SERVICE PROCEDURE

**26506
June 2026**

SUBJECT: SAFETY RECALL

VEHICLE RECALL 26506

Figure 1. Fitting Locations

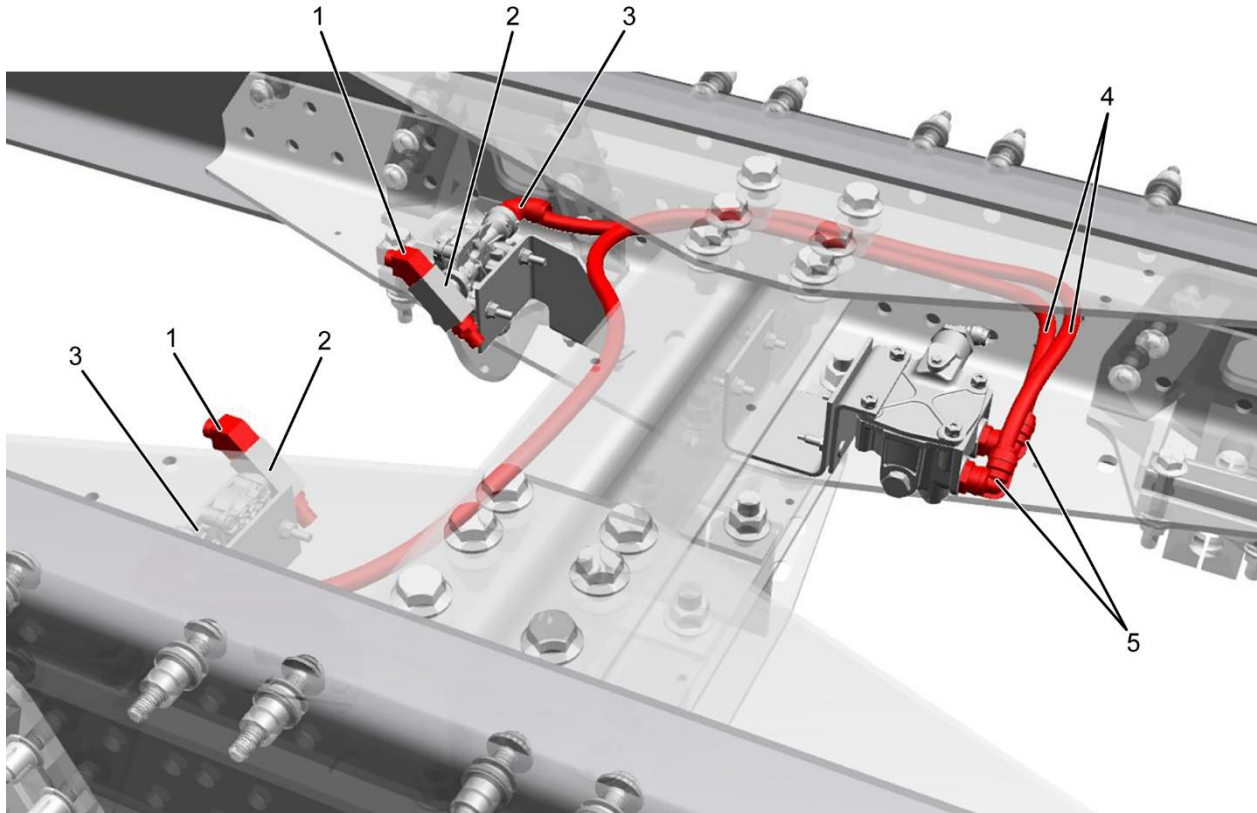
Certain International® HV™ Series trucks with a walking beam with multi-leaf suspensions and 4-channel ABS do not meet FMVSS-121 S5.3.4 brake release timing requirement. Each service brake system shall meet the requirements of S5.3.4.1 (a).

S5.3.4.1 (a) With an initial service brake chamber air pressure of 95 psi, the air pressure in each brake chamber shall, when measured from the first movement of the service brake control, fall to 5 psi in not more than 0.55 seconds.

6. Starting on the driver-side, remove the 5/8-inch air line from the relay valve to the modulator valve (Figure 1, Item 4).
7. At the relay valve, remove the 5/8-inch 90-degree elbow and install the 3/4-inch 90-degree elbow. (Figure 1, Item 5).
8. At the modulator valve, remove the 5/8-inch 90-degree elbow and install the 3/4-inch 90-degree elbow. (Figure 1, Item 3).

9. Using the 5/8-inch airline that was removed as a template, cut a section of 3/4-inch airline to the same length.
10. Install air line into fittings that were replaced.
11. Repeat Steps 5 through 10 for the passenger-side of the vehicle.
12. Determine whether your vehicle is equipped with 0004AZA (Bendix 4 Channel ABS) or 0004AZJ (Bendix 4 Channel ABS with Automatic Traction Control) or VINs listed below:
 - a. For VINs with 0004AZJ (Bendix 4 Channel ABS with Automatic Traction Control), go to Step 13.

Figure 2. Modulator Valve with Quick Release Valve Installed

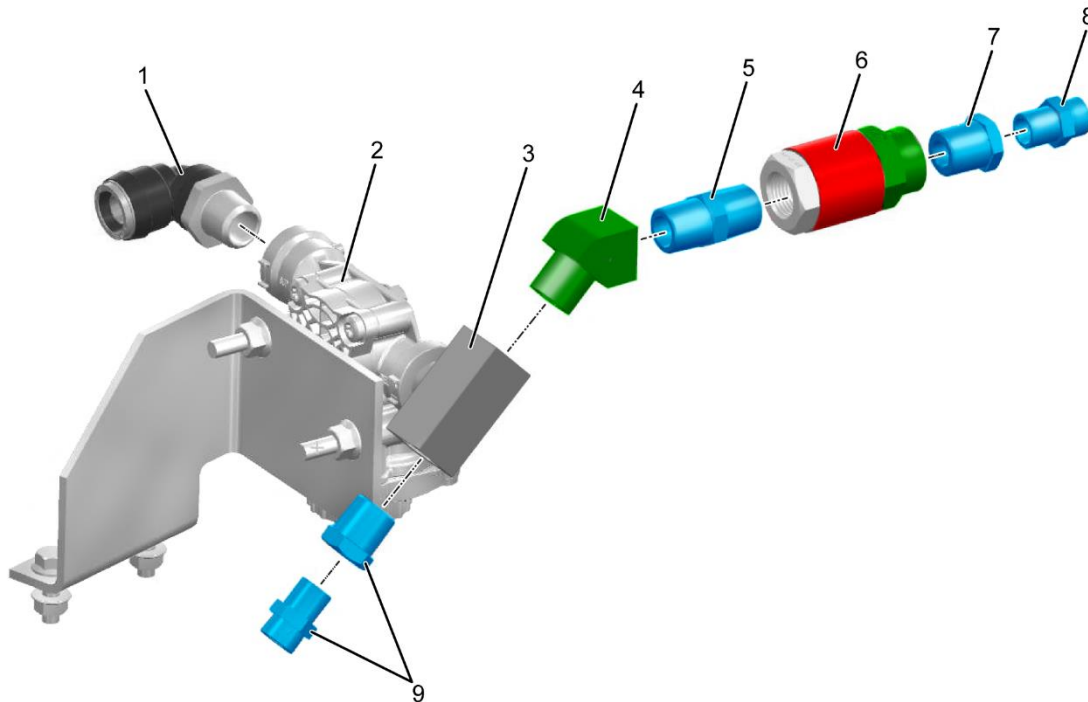
13. Starting on the driver-side, remove the air hose going to the rear rear brake chamber from the 45-degree fitting at the modulator valve (Figure 2, Item 2).

14. Note the angle of the 45-degree fitting and using a backup wrench, remove the 45-degree fitting from the tee fitting (Figure 2, Item 3).

15. Using a backup wrench in the same orientation notated in Step 14, install and tighten new elbow (Figure 2, Item 4) into 90-degree fitting on relay valve (Figure 1, Item 5).

16. Install and tighten nipple (Figure 2, Item 5) into elbow (Figure 2, Item 4).
17. Install and tighten quick release check valve (Figure 2, Item 6) into nipple (Figure 2, Item 5) with air pointing toward the rear rear brake chamber hose.

18. Install and tighten reducer bushing (Figure 2, Item 7) into the quick release valve (Figure 2, Item 6).
19. Install adapter (Figure 2, Item 8) in recently installed reducer bushing (Figure 2, Item 7).

20. Install and tighten air hose that was removed in Step 13 into the adapter (Figure 2, Item 8).
21. Repeat Steps 13 through 20 on passenger-side.
22. In the cab, release the parking brake and check for air leaks at hoses and fitting just installed. Repair any leaks if found.
